Addendum No. 2
December 10, 2021

Project: Harrisburg High School - 9th Grade Academy
Sioux Falls, South Dakota
Architecture Incorporated Project #2904

Architect: Architecture Incorporated

SECOND FLOOR PLAN - AREA A - VENTILATION & A/C

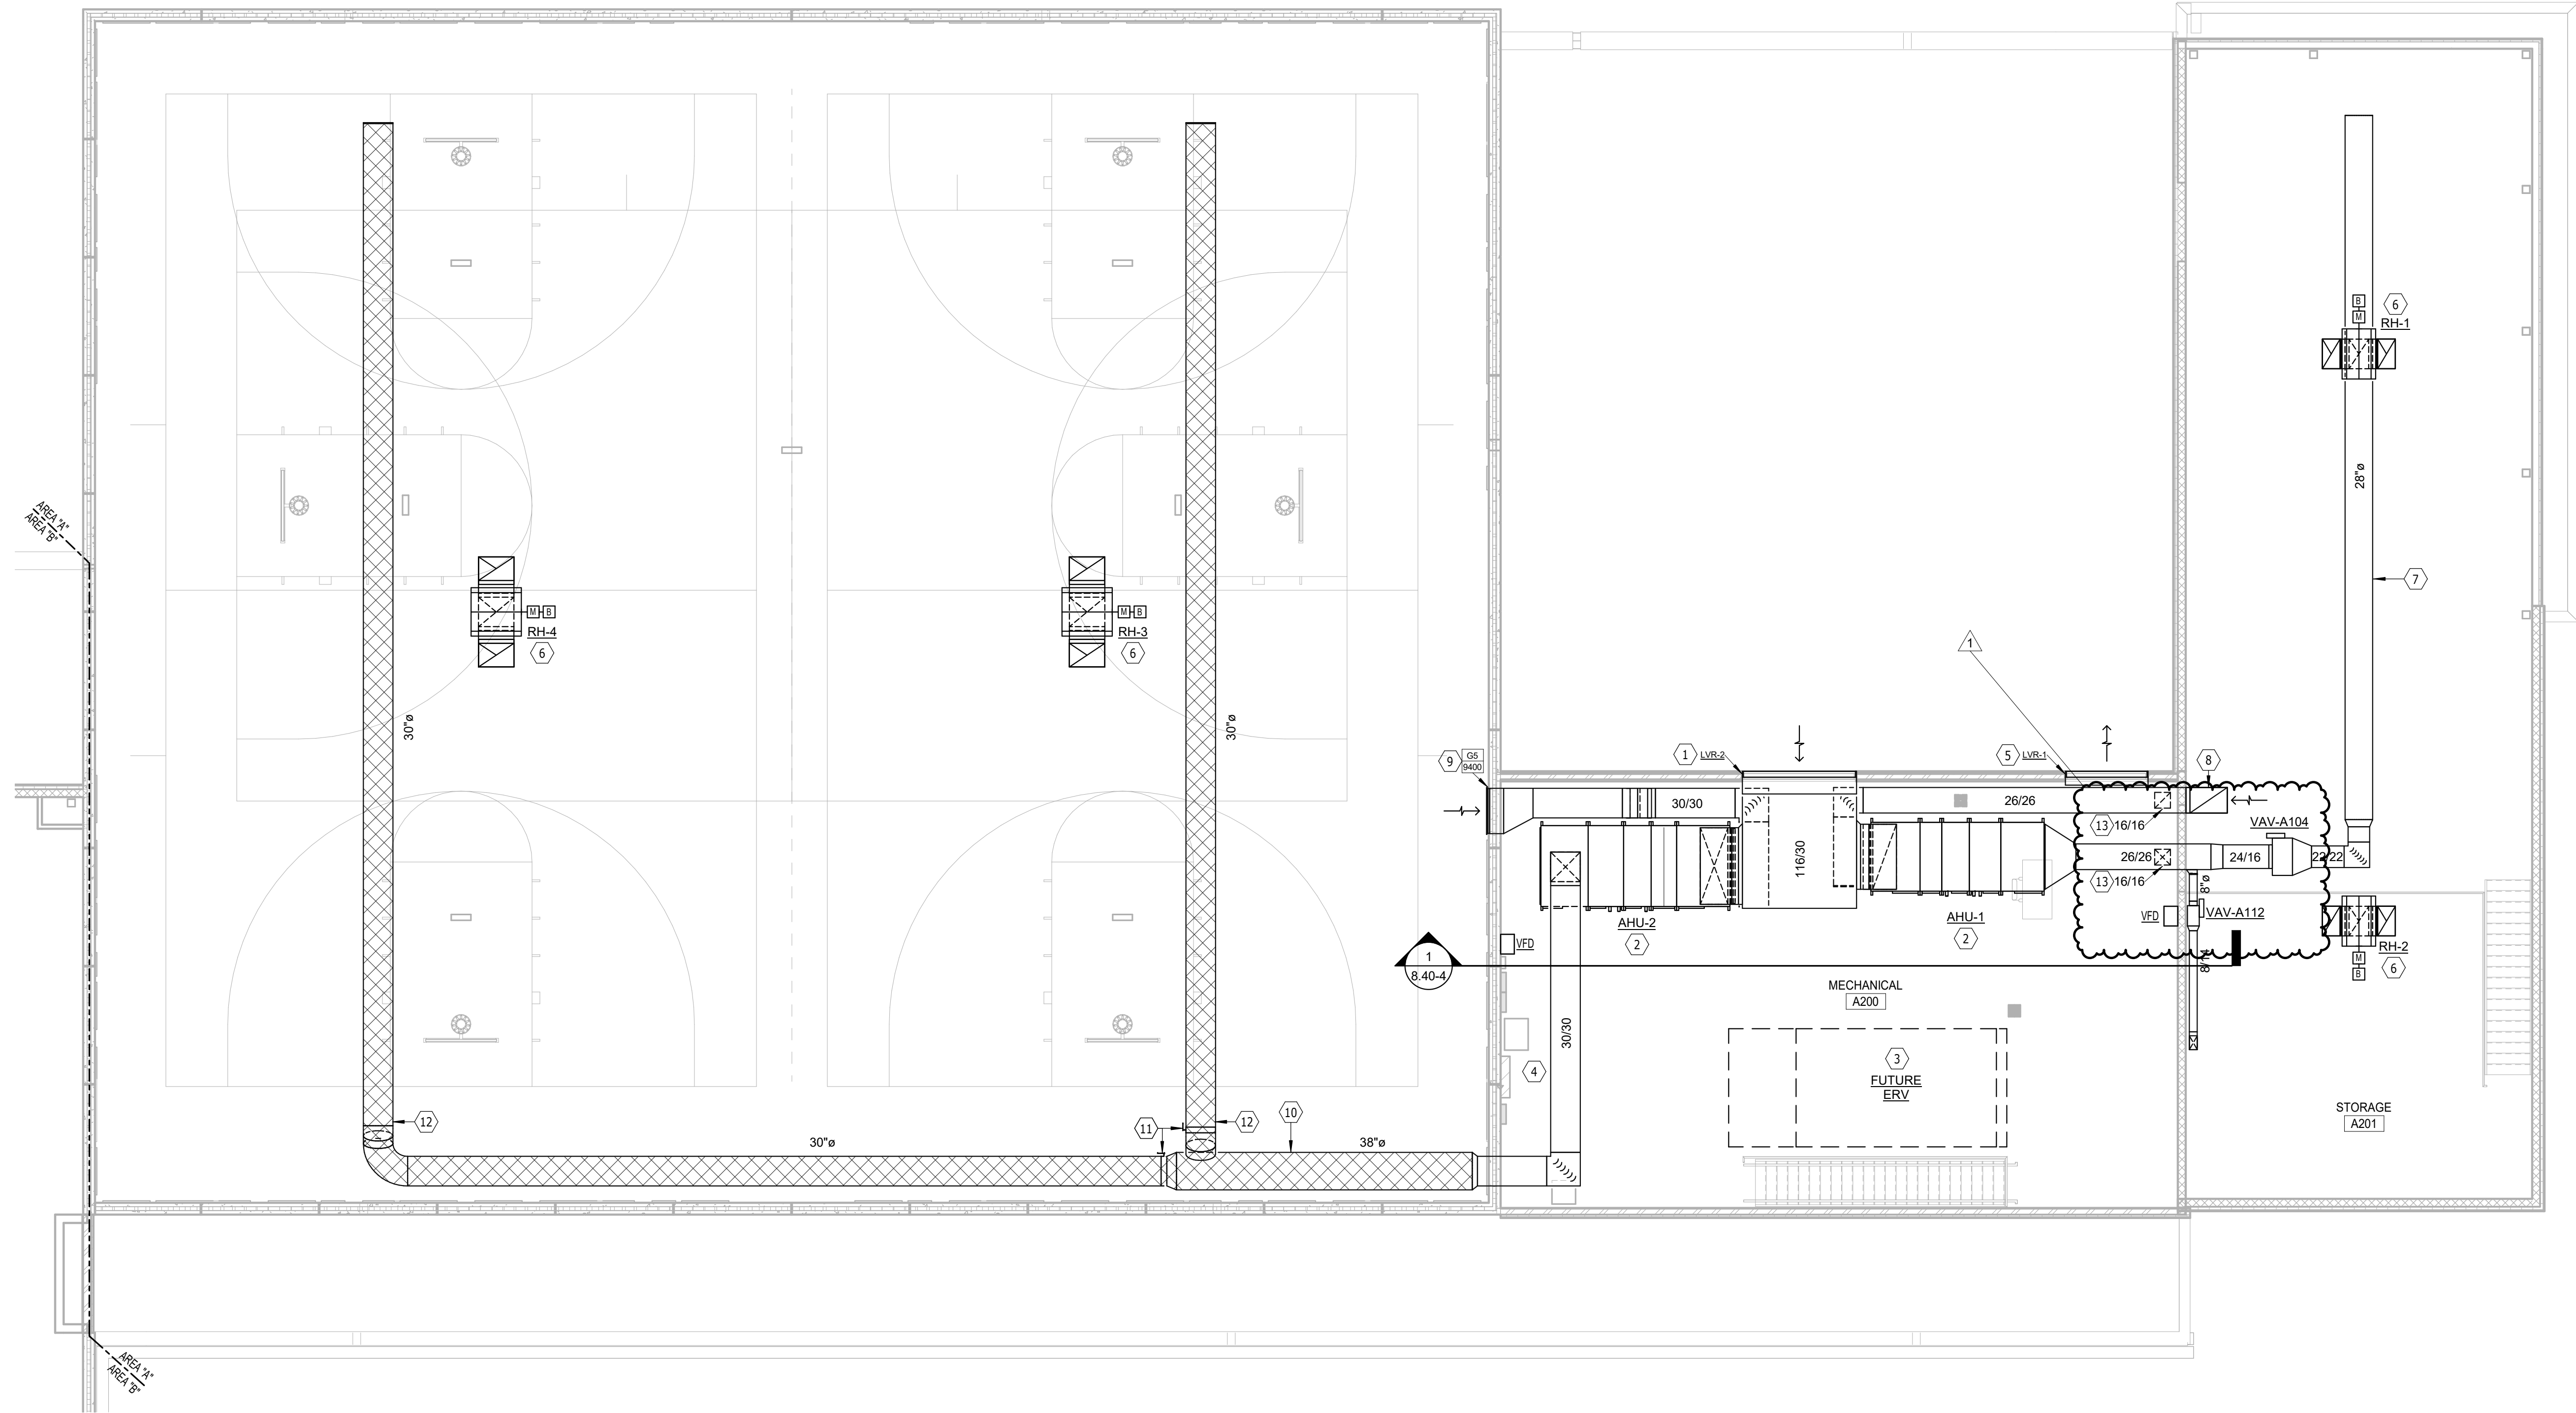
- a) Revise supply and return duct drops. Add VAV-0a104 and VAV-A112. Refer to revised drawing sheet 8.40-2A, ADDM M2, dated 12/10/21.

8.40-2C

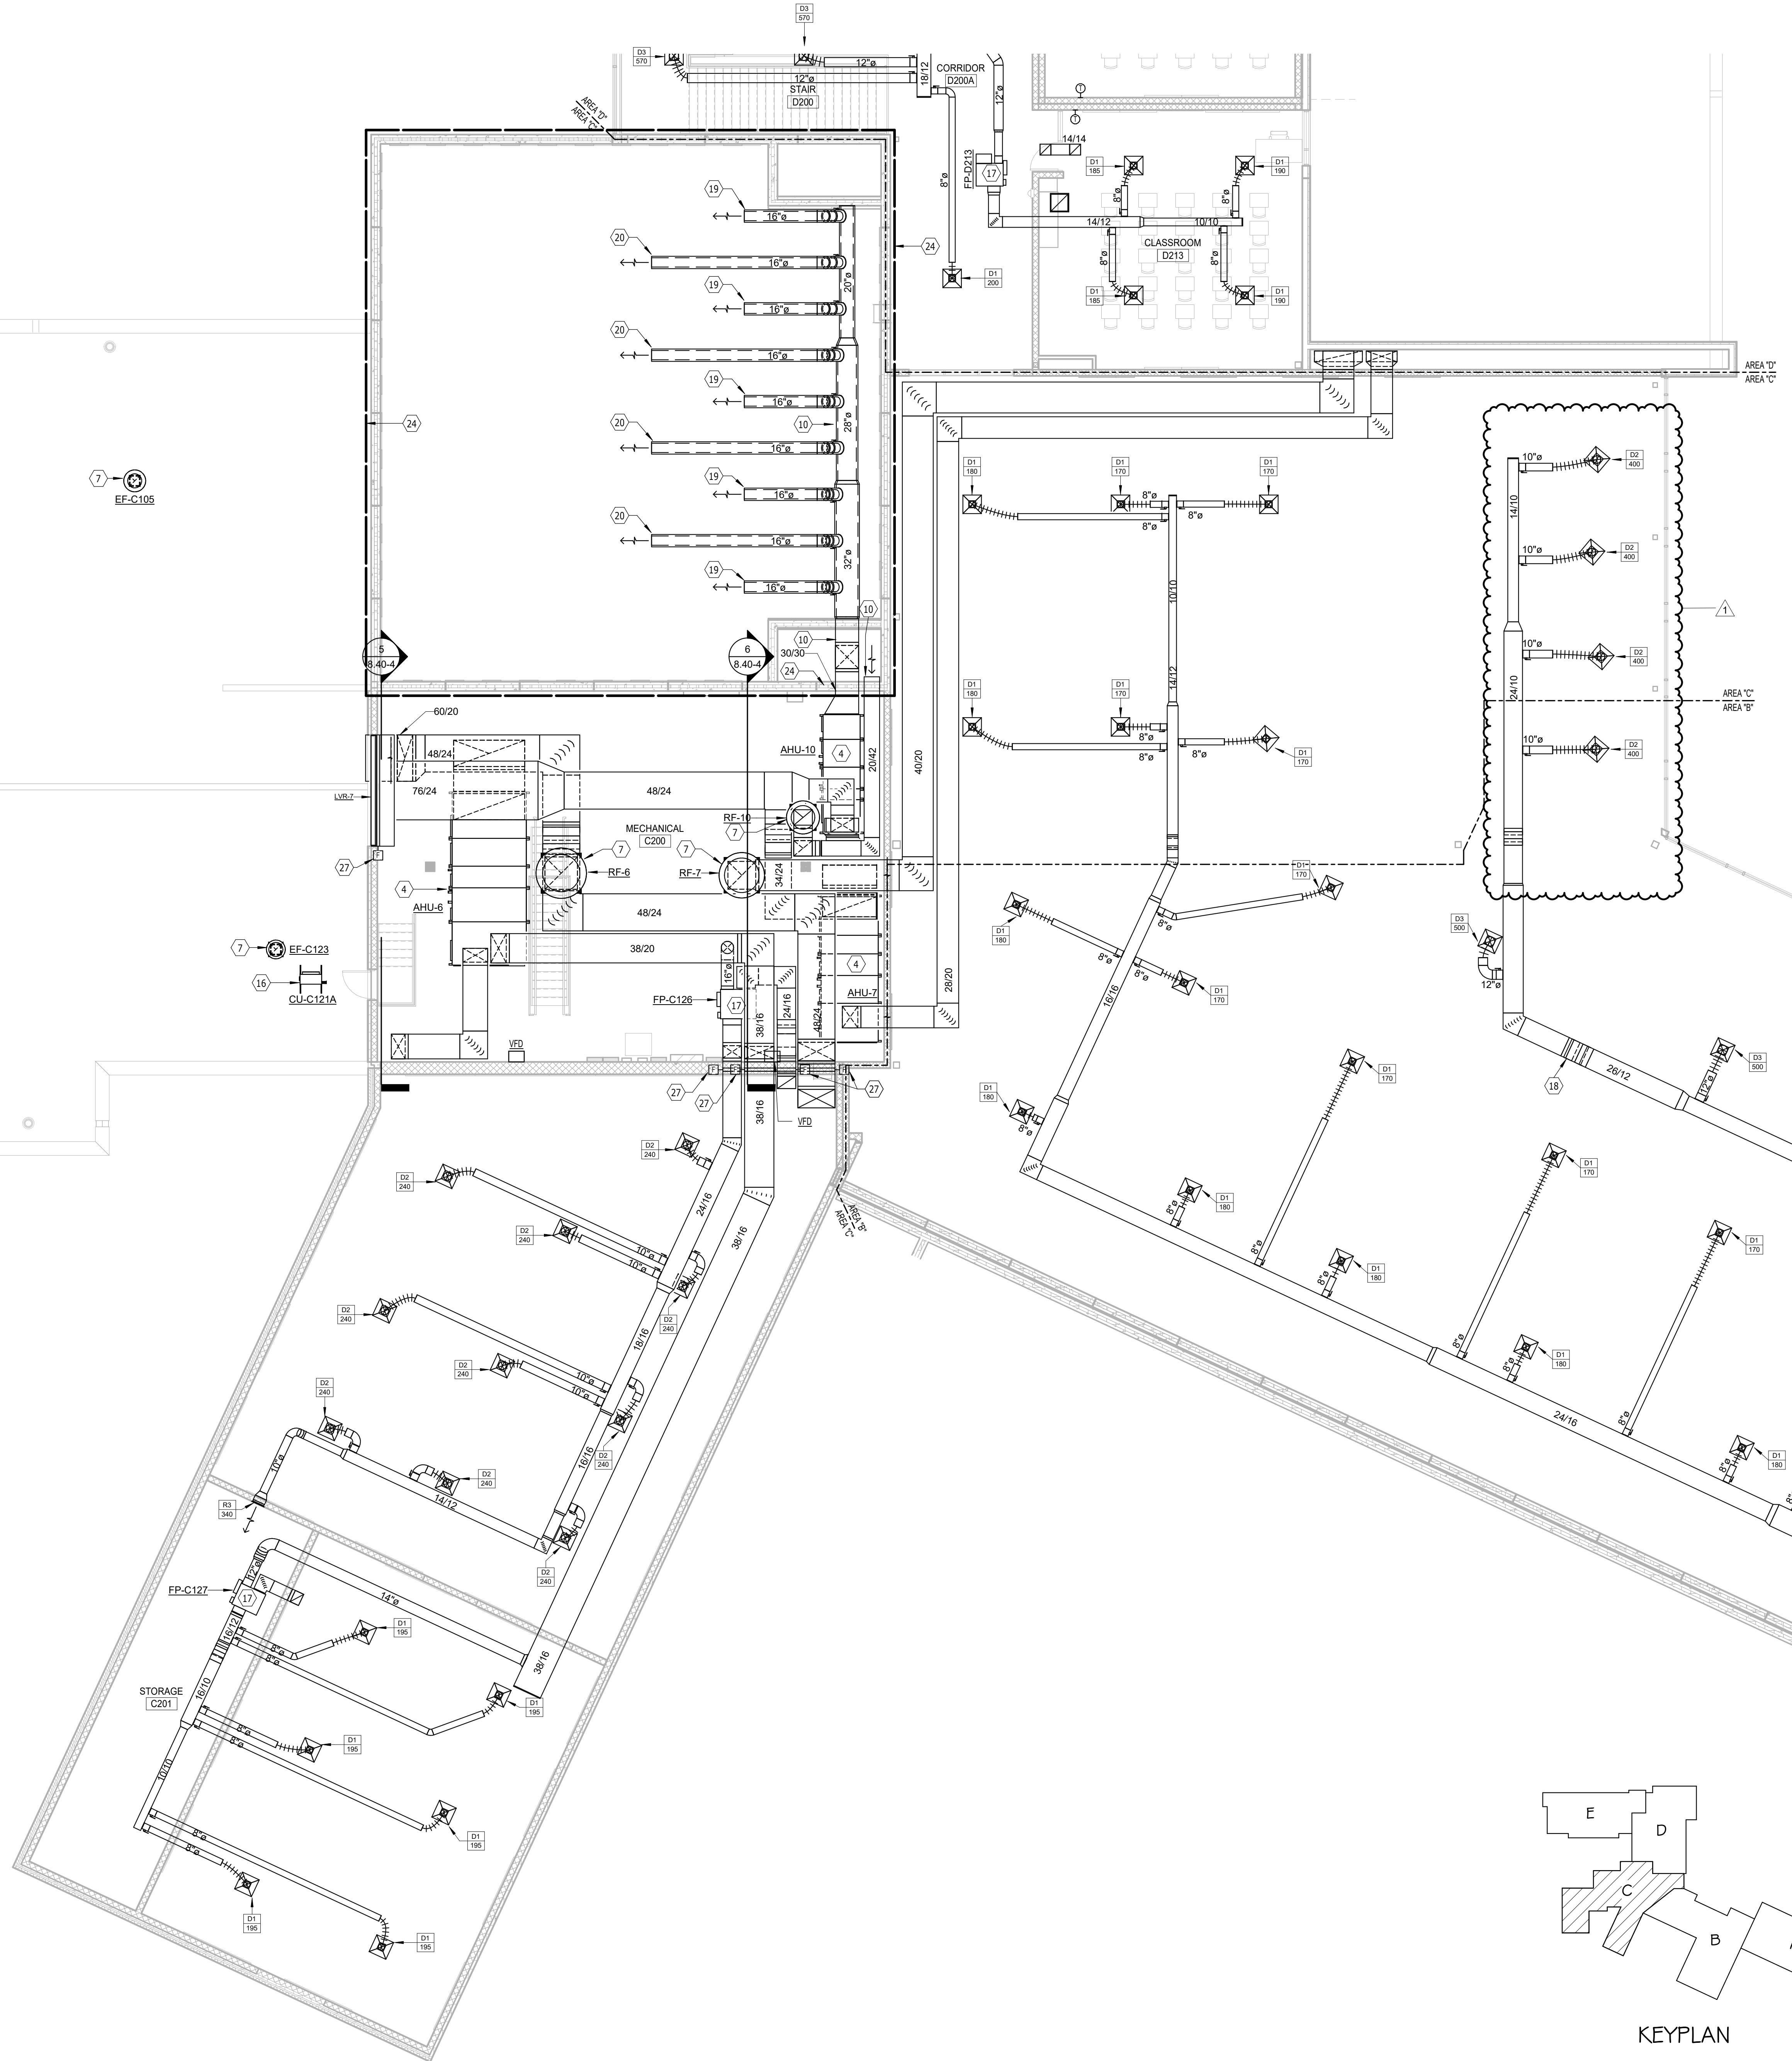
- a) Revise duct sizing and add (4) D2 diffusers. Refer to revised drawing sheet 8.40-2C, ADDM M2, dated 12/10/21.

8.40-2E

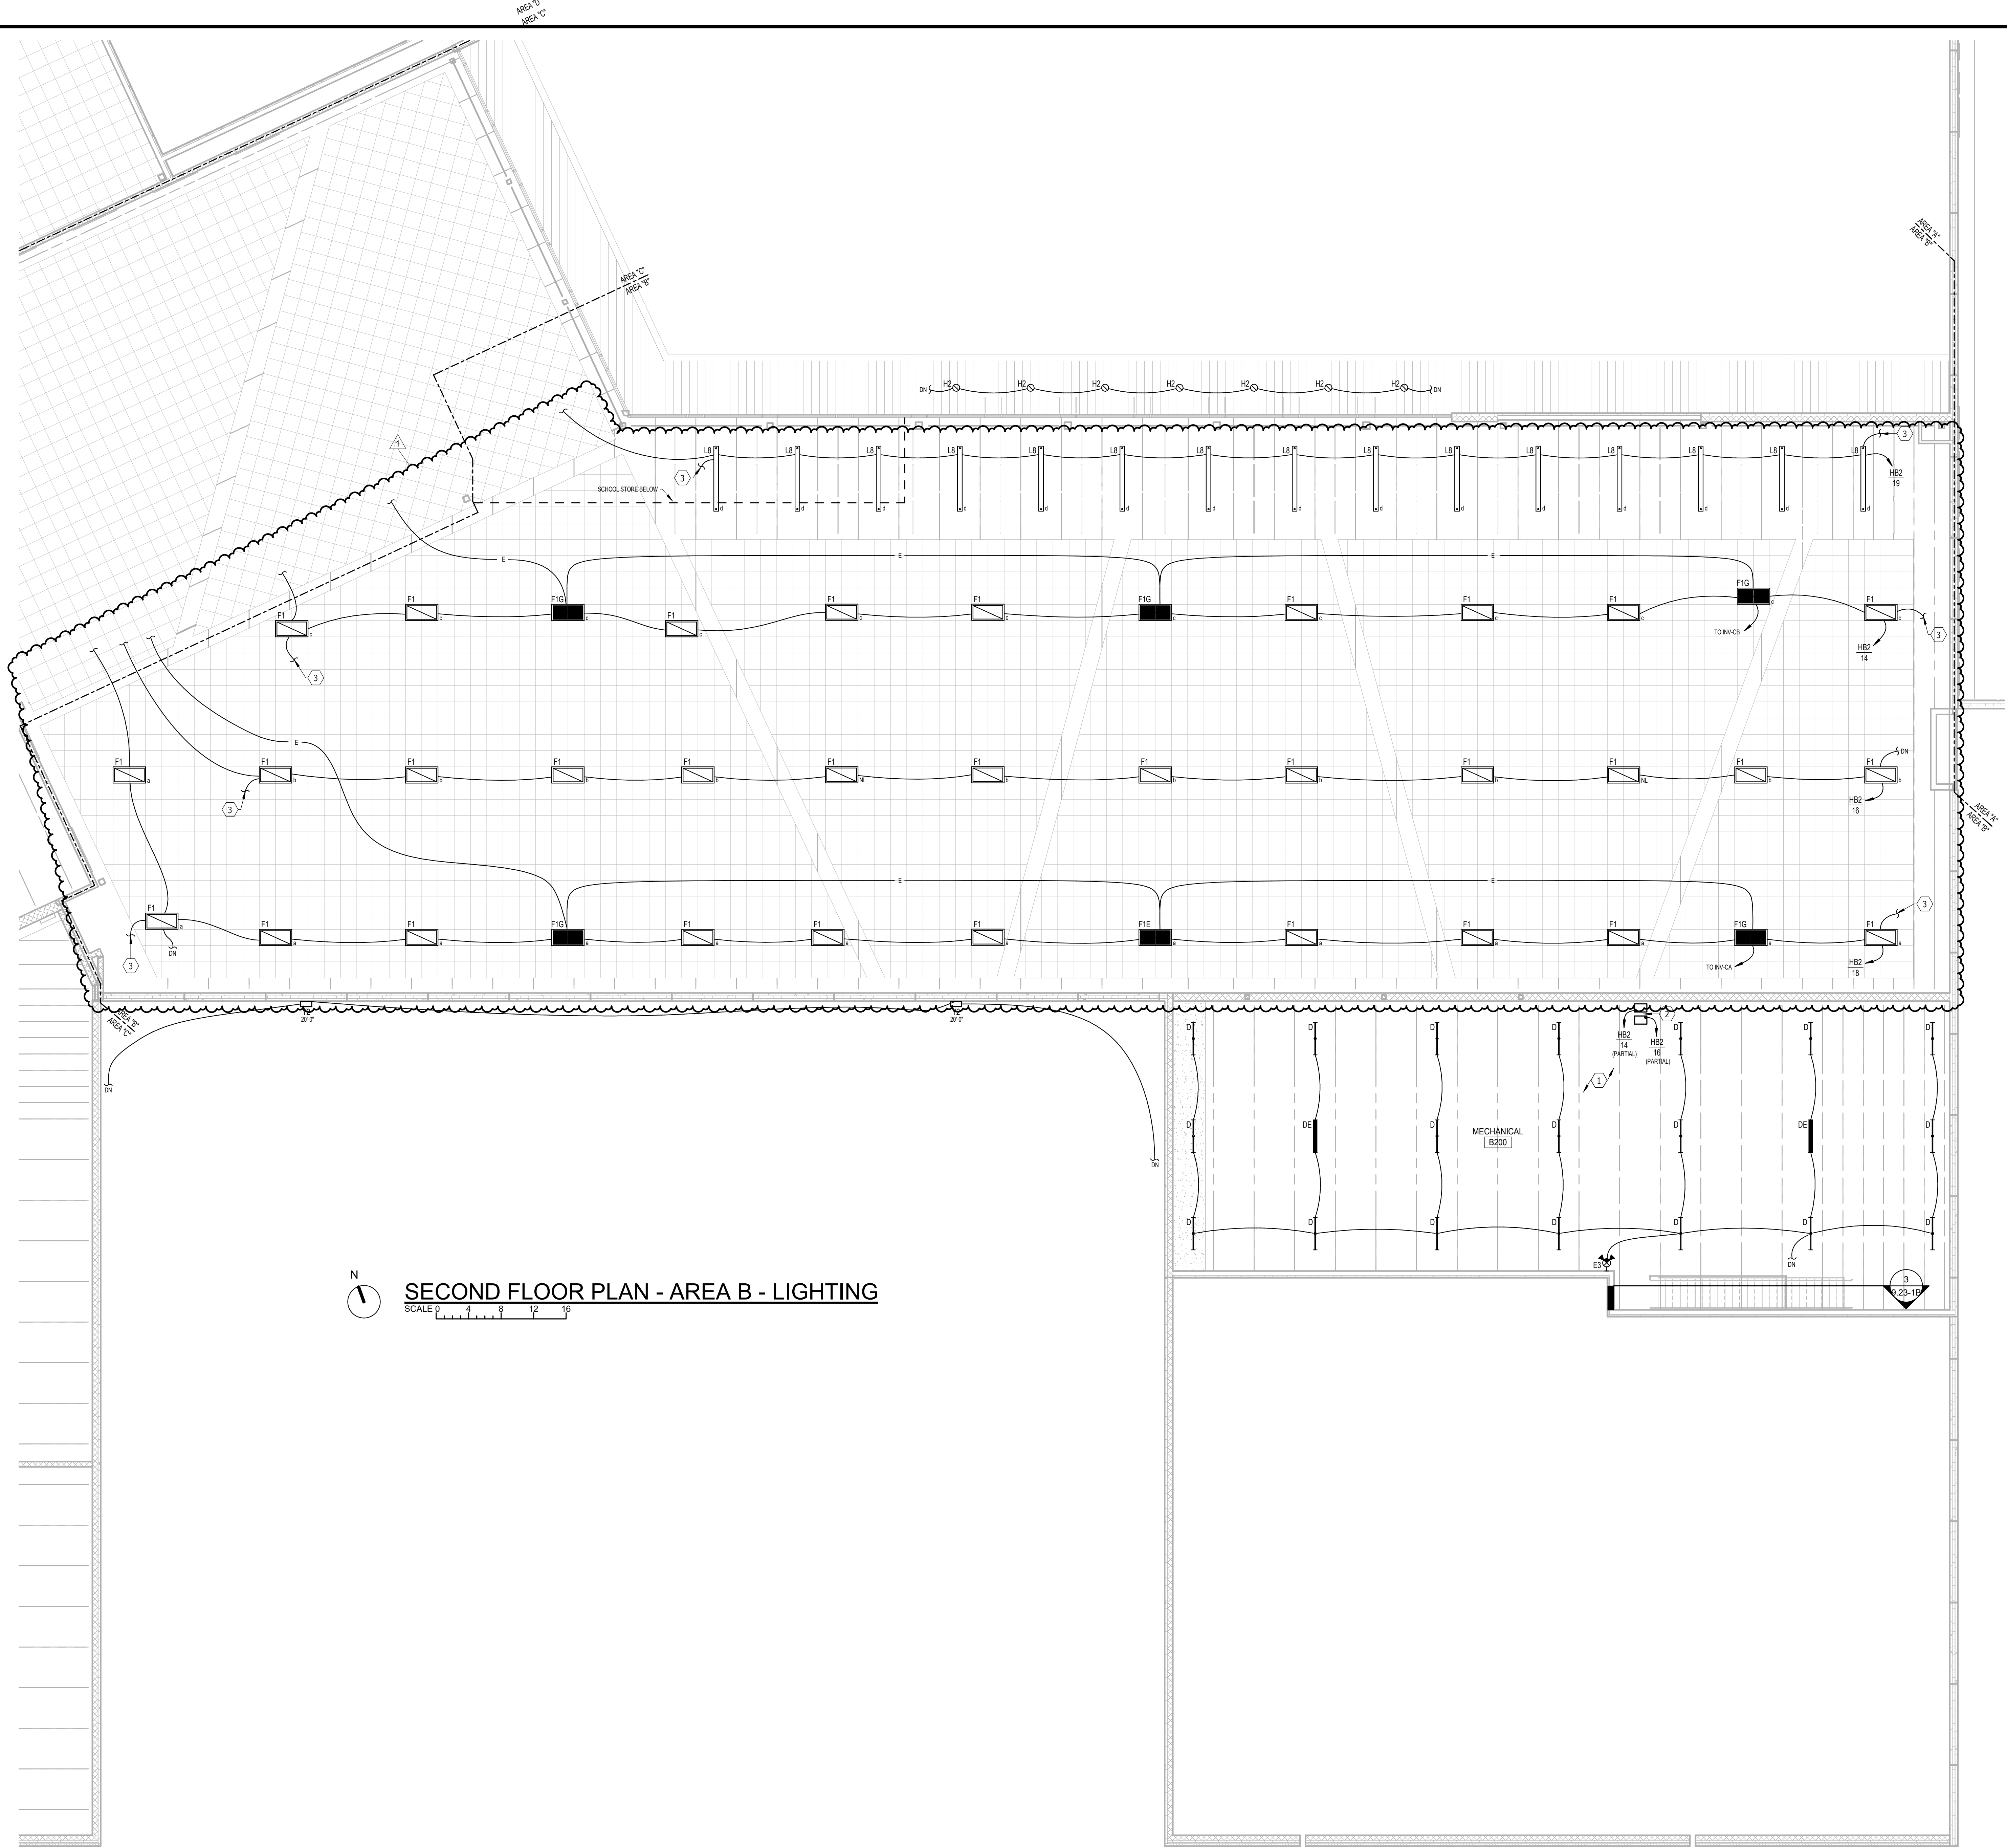
- a) Add Note 11: ***EXPOSED SPIRAL DUCT THRU CORRIDOR SHALL BE DOUBLE WALL CONSTRUCTION.*** Revise locations of EF-220, EF-223 and EF-225. Refer to revised drawing sheet 8.40-2E, ADDM M2, dated 12/10/21.
- b) Omit the fire damper shown at louver LVR-7 at the west side of Mechanical C200; not required.

- EXPOSED SPIRAL DUCT THRU CORRIDOR SHALL BE DOUBLE WALL CONSTRUCTION.
